# **Statutory Public Meeting**

Proposed Amendments to the Town's Official Plan and Zoning By-law 2010-0050

**Applicant: Support House**

47 Maria Street Town of Halton Hills (Acton)

### **Planning Policy Context** Halton Hills Zoning By-law 2010-0050

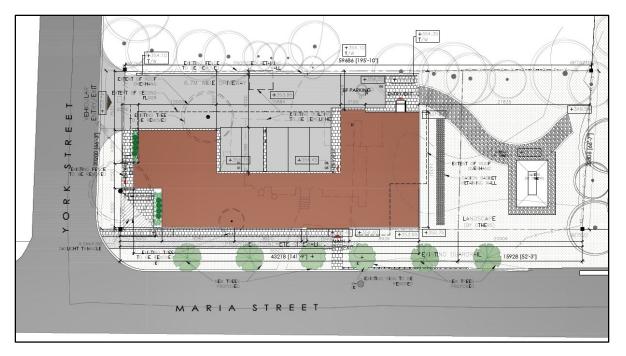
The proposed 0 metre building setback along Maria Street would result in the eaves and main entrance door (when in the open position) encroaching into the Town's right-of-way, which is not permitted

Site plan drawing must demonstrate that sufficient vehicular sightlines are being provided for the proposed driveway off York Street
